PAVING PLAN

PHASE 1 - KAUMUALII HIGHWAY
LIHUE MILL BRIDGE TO RICE STREET

PHASE 3 - REHABILITATION OF LIHUE MILL
BRIDGE AND MAKAI WIDENING

AS-BUILT

SHEET No. C-33 OF 82 SHEETS

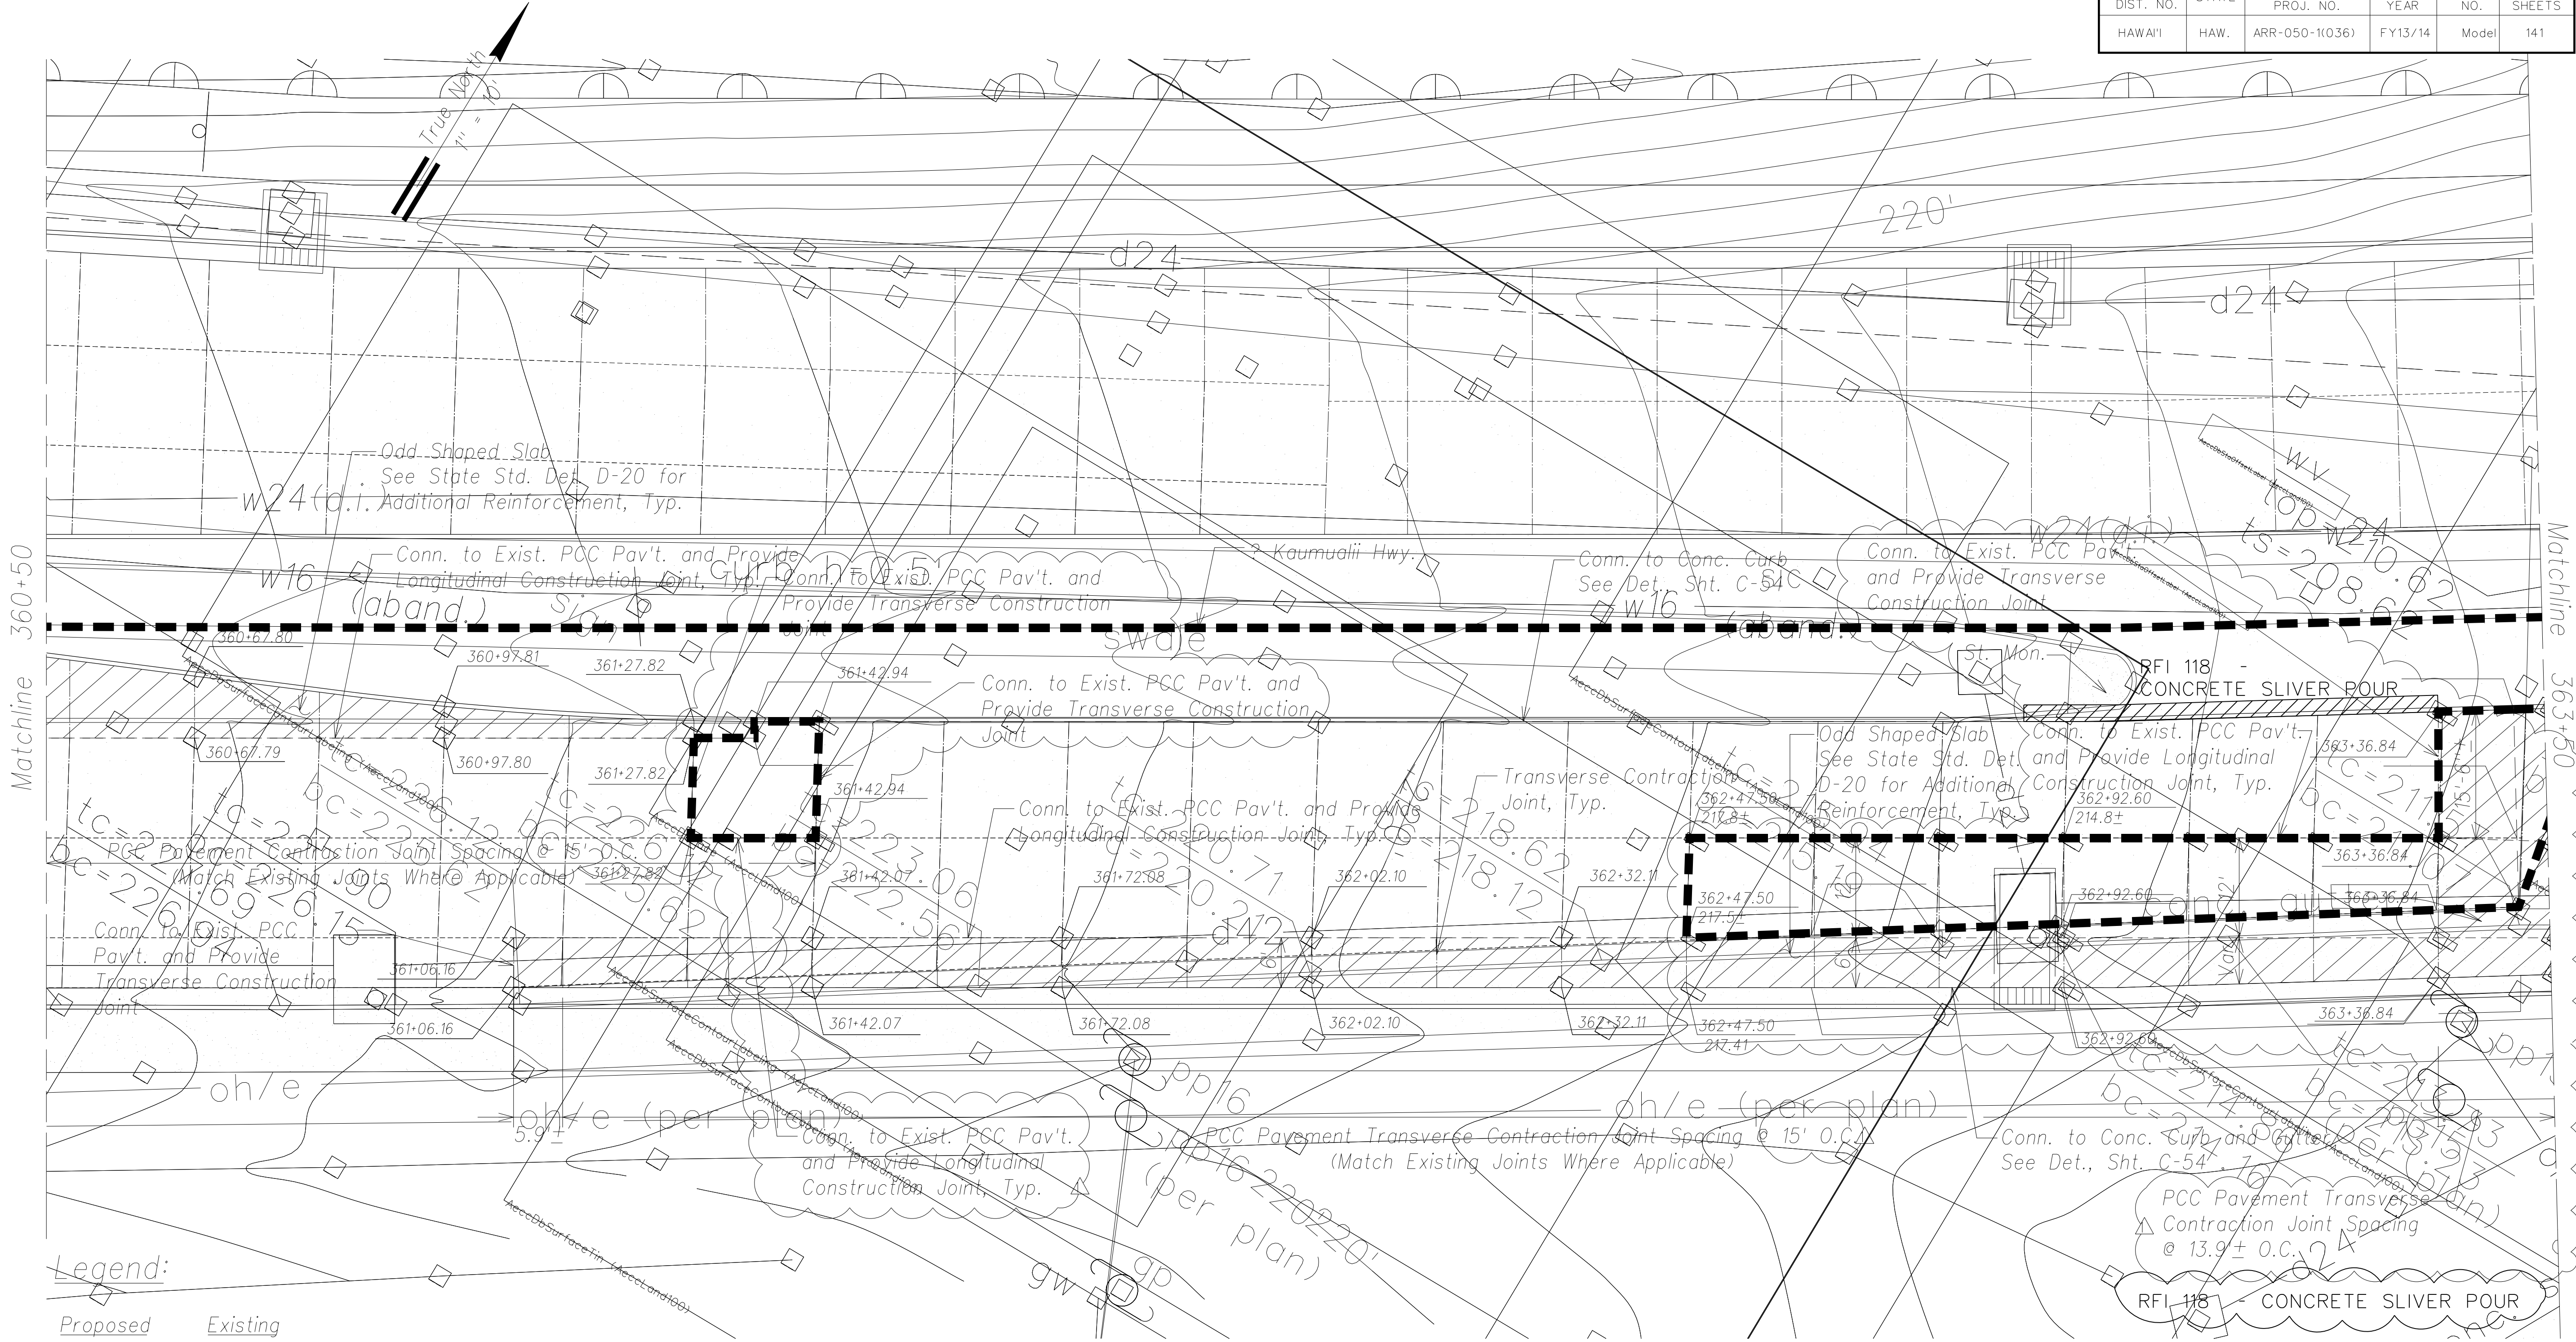
4/6/15
Date
Revision
Revise jointing. Add st. mon.

SHEET No. C-36 OF 82 SHEETS

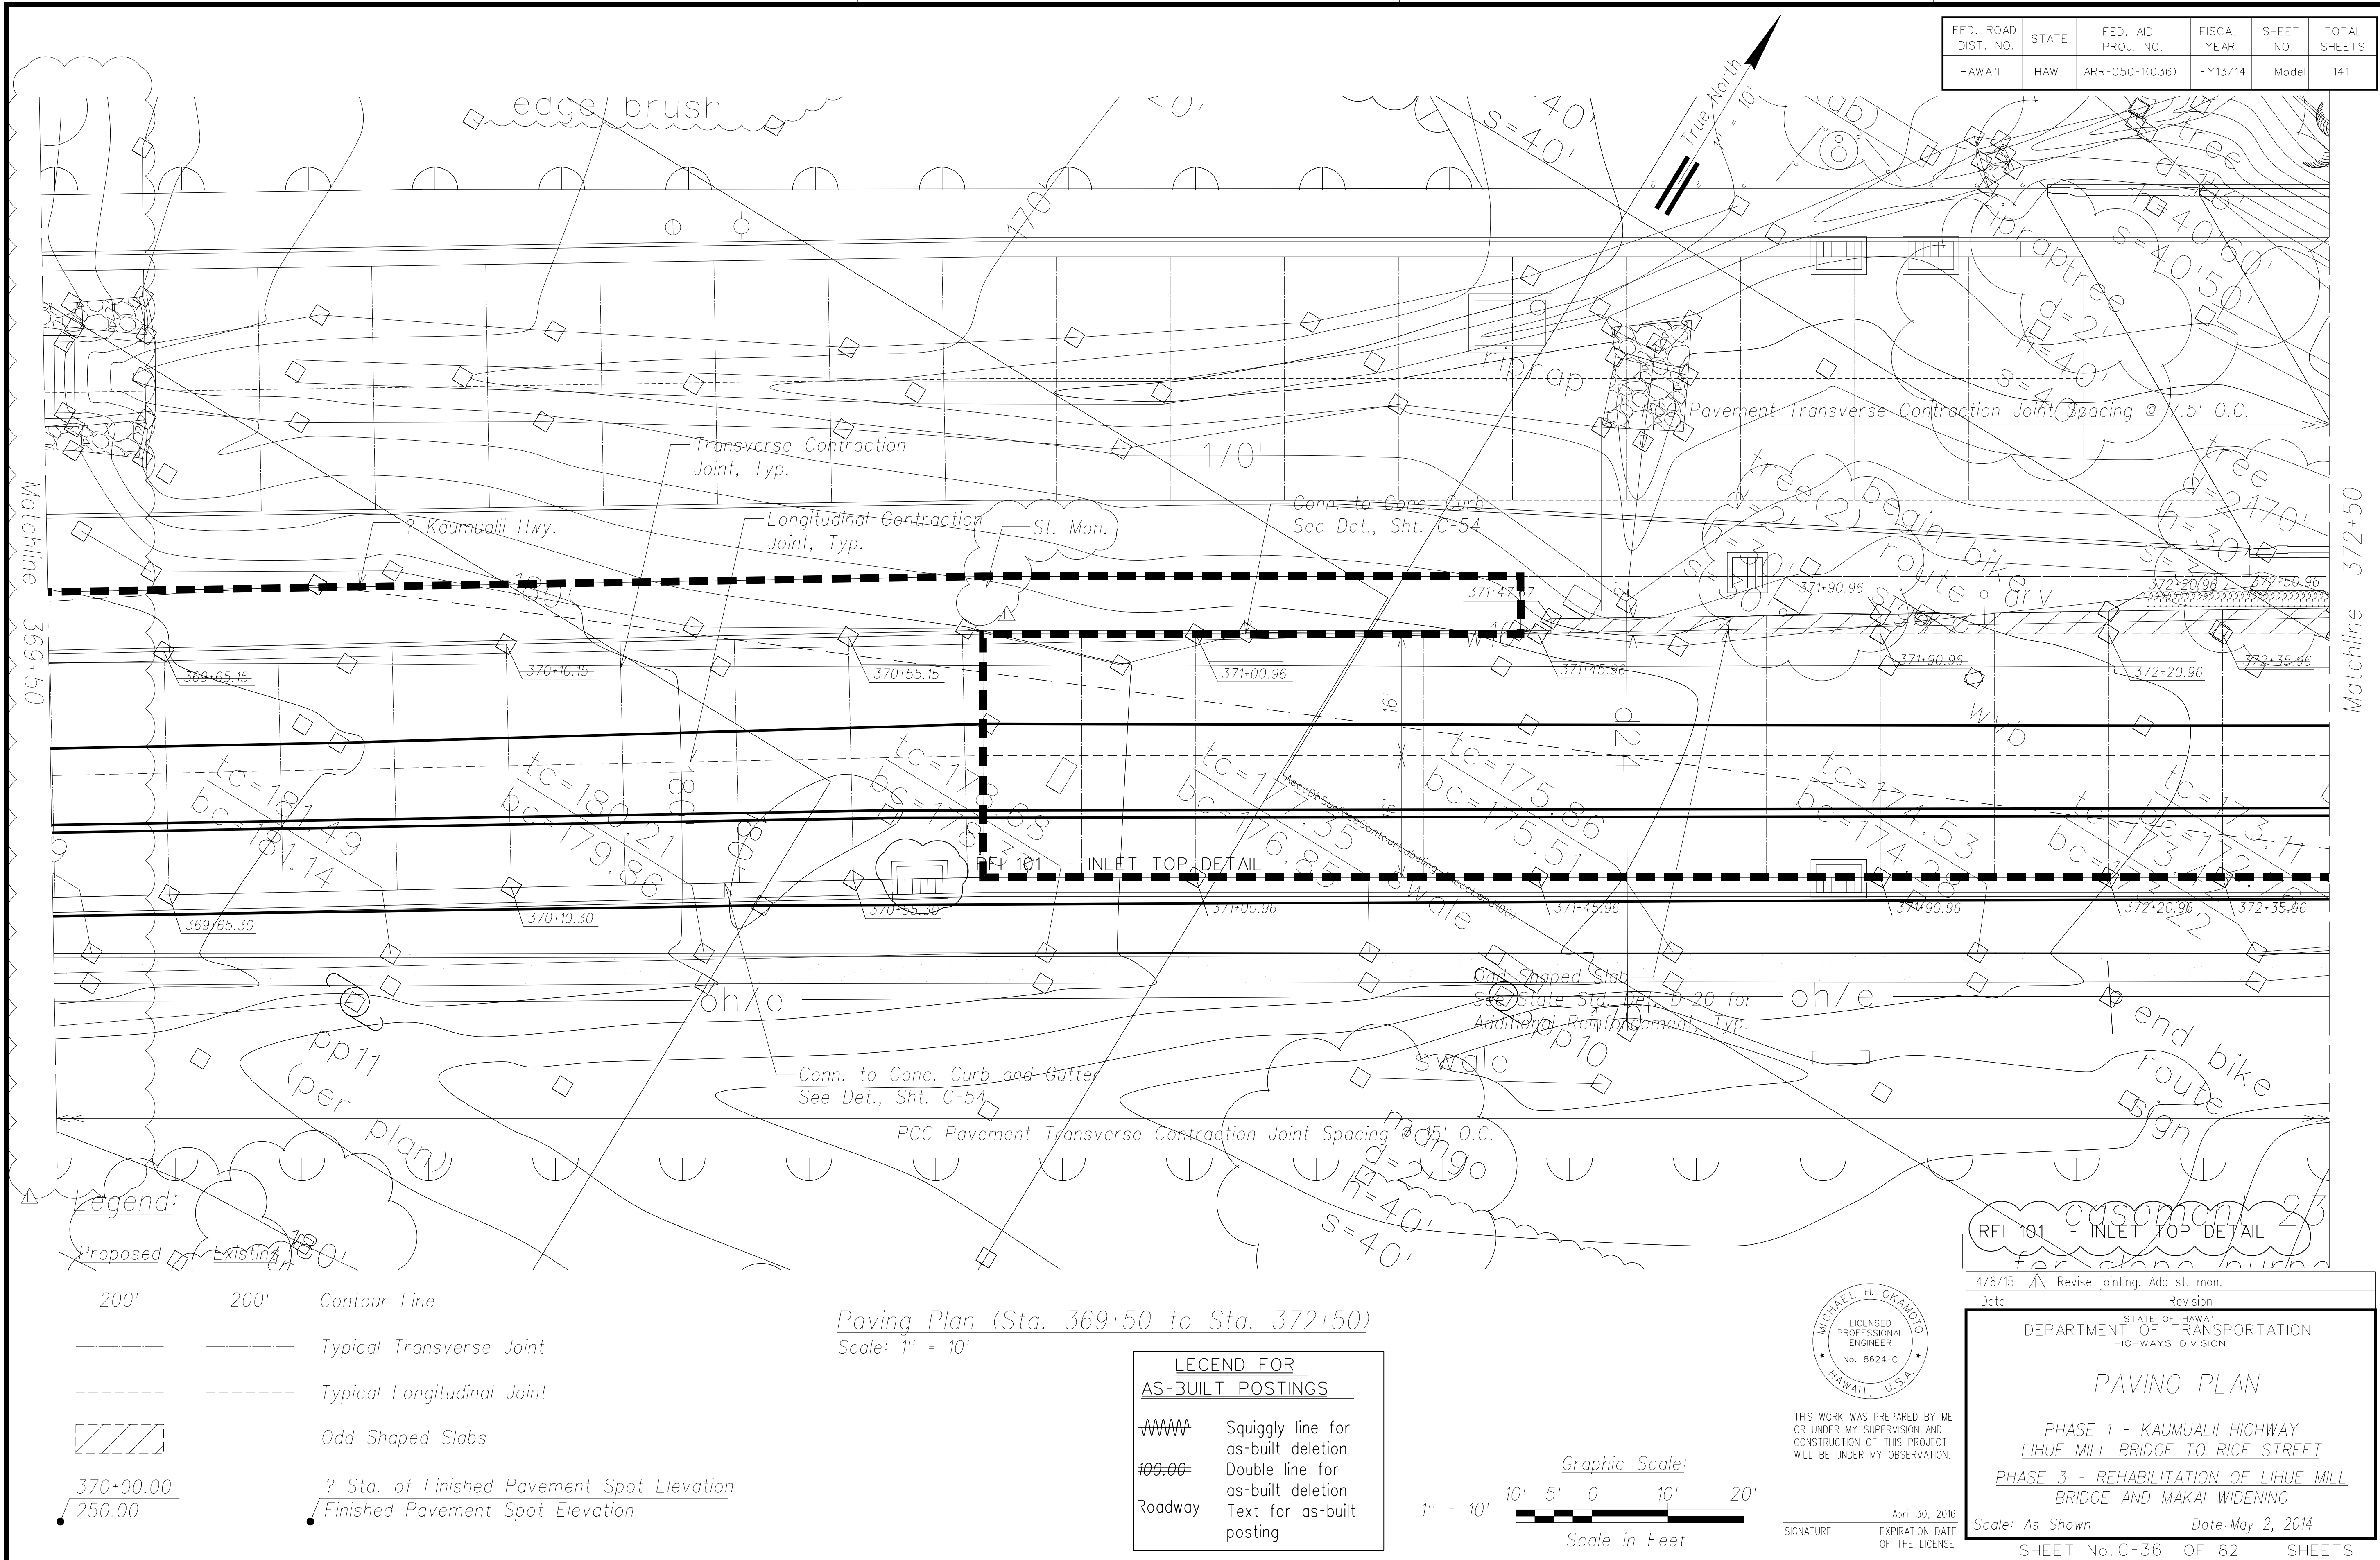
RFI 101 - INLET TOP DETAIL

NCR NO. 30 - GDI B-5 CRACK RFI-101-INLET TOP DETAIL
 DEPARTMENT OF TRANSPORTATION HIGHWAYS DIVISION
 PAVING PLAN (STA. 372+50 TO STA. 375+25)
 PHASE 1 - KAUMUALII HIGHWAY LIHUE MILL BRIDGE TO RICE STREET
 PHASE 3 - REHABILITATION OF LIHUE MILL BRIDGE AND MAKAI WIDENING
 Scale: As Shown Date: May 2, 2014
 SHEET No. C-37 OF 82 SHEETS

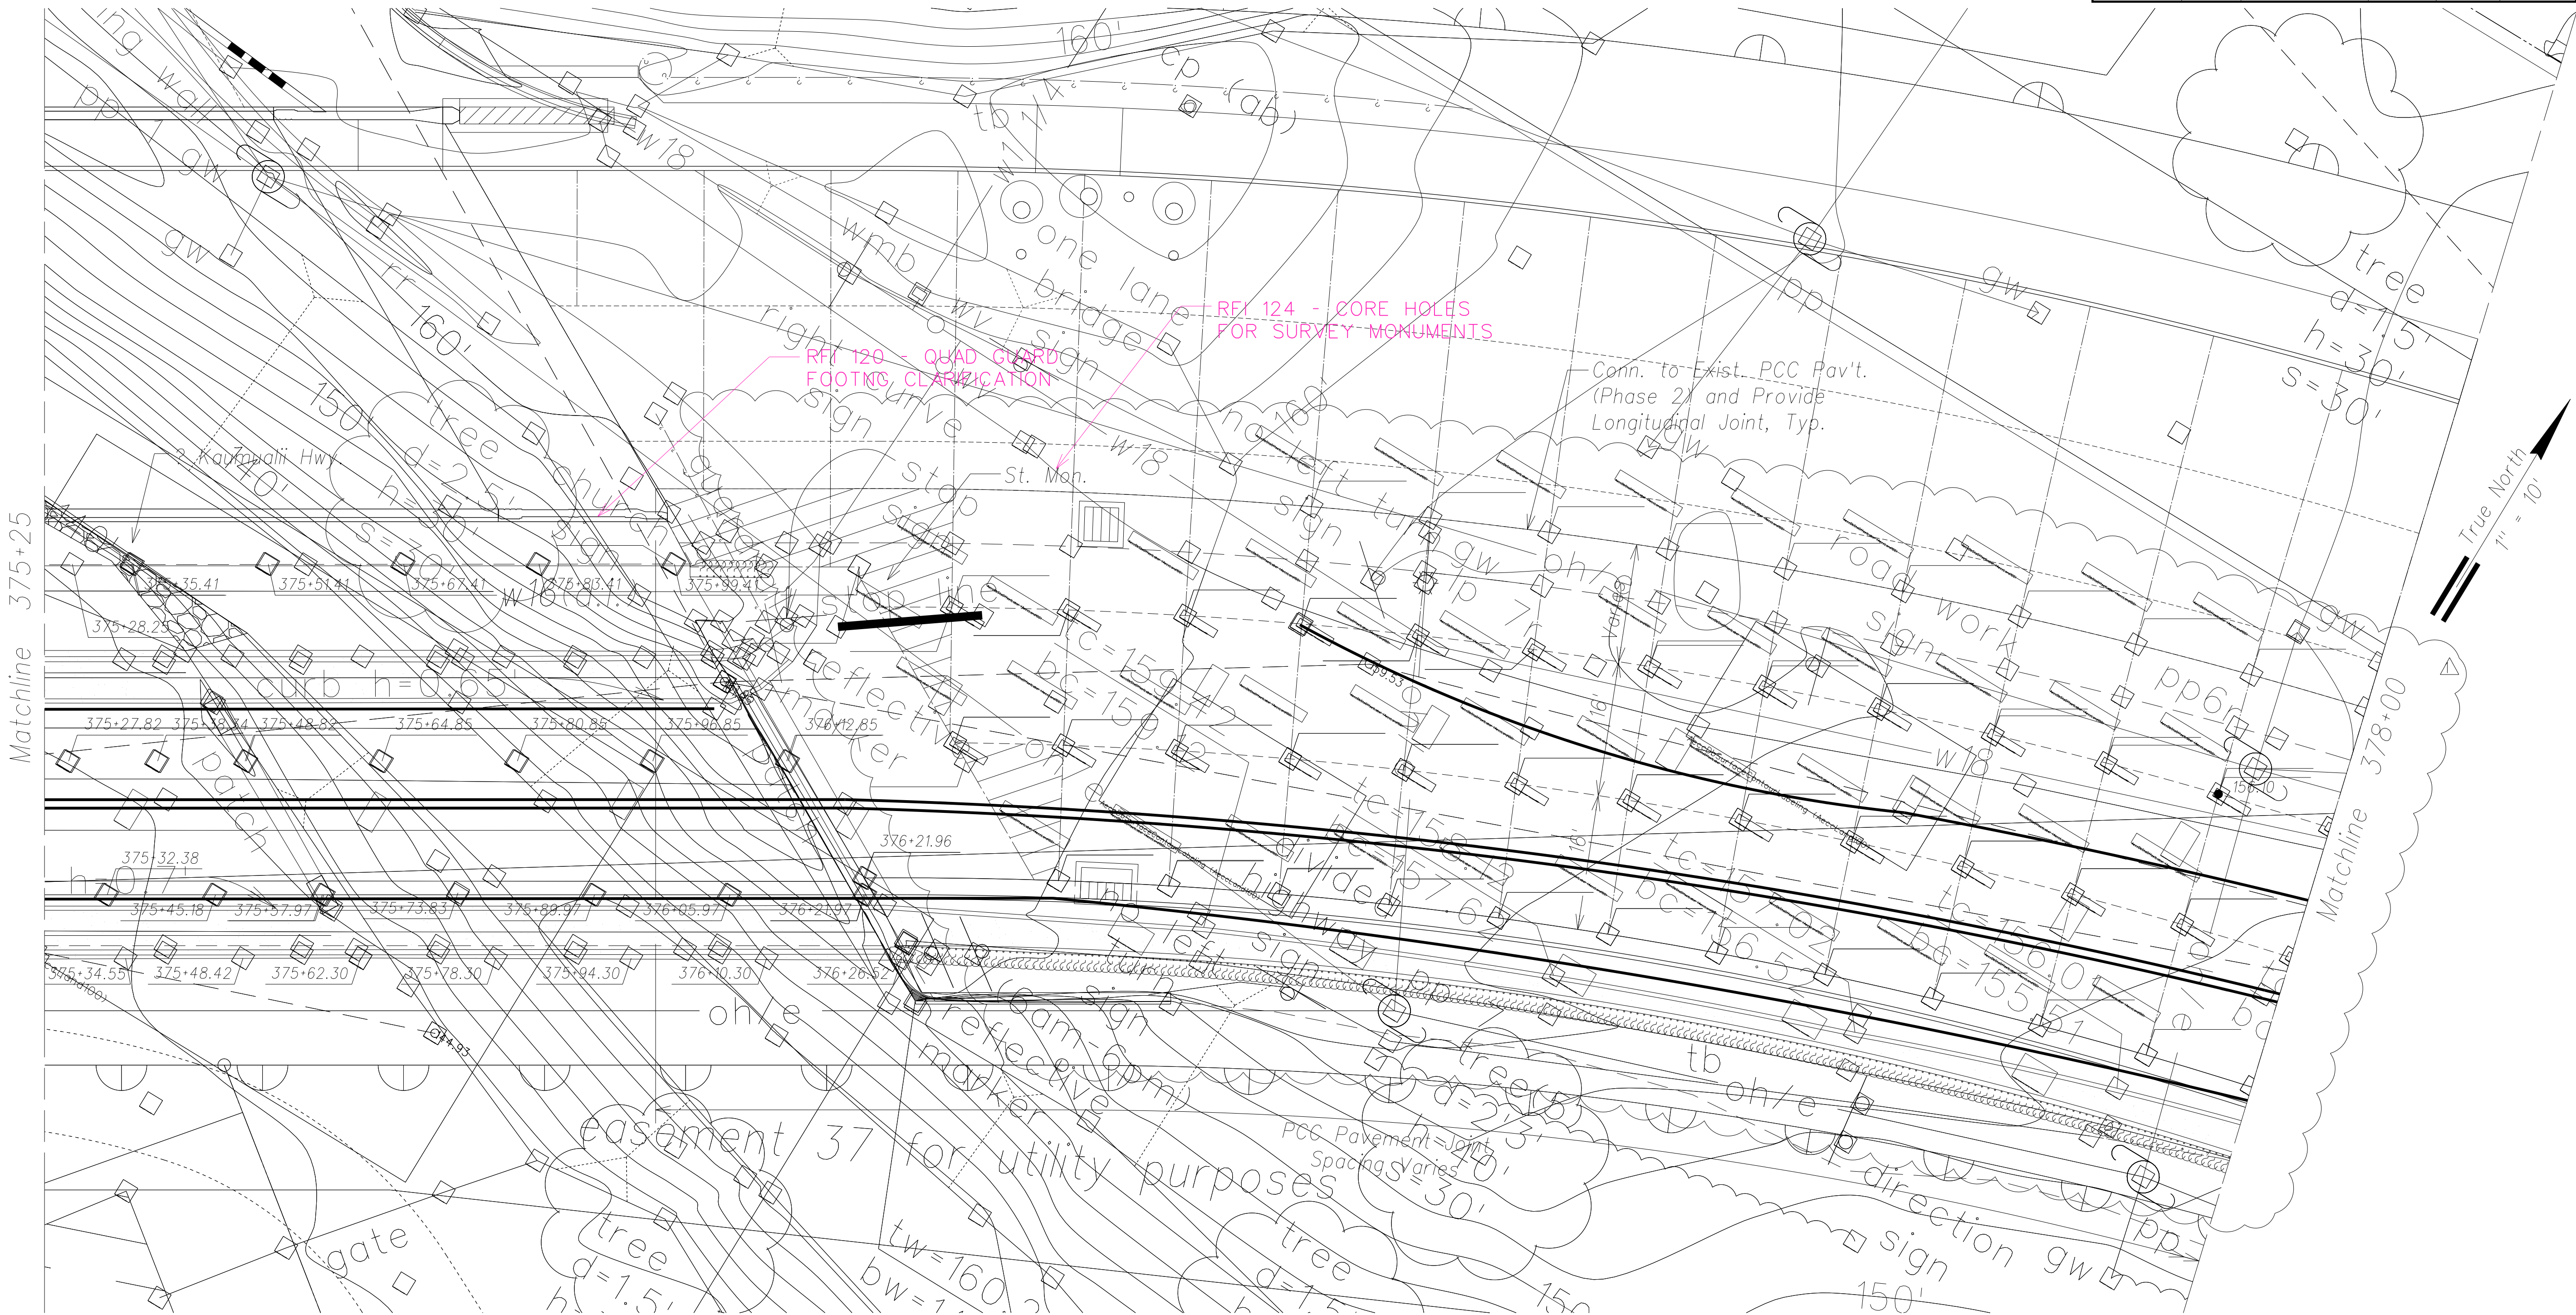
- RFI 124 - CORE HOLES FOR SURVEY MONUMENTS
- RFI 121 - GDI TOP DETAILS
- RFI 120 - QUAD GUARD FG
- RFI 101 - INLET TOP DETAIL

4/6/15
Date
Rev. for add'l PCC pav't and sidewalk. Add st. mon.
Revision
STATE OF HAWAII
DEPARTMENT OF TRANSPORTATION
HIGHWAYS DIVISION
PAVING PLAN
PHASE 1 - KAUMUALII HIGHWAY
LIHUE MILL BRIDGE TO RICE STREET
PHASE 3 - REHABILITATION OF LIHUE MILL BRIDGE AND MAKAI WIDENING
Scale: As Shown
Date: May 2, 2014
SHEET No. C-38 OF 82 SHEETS
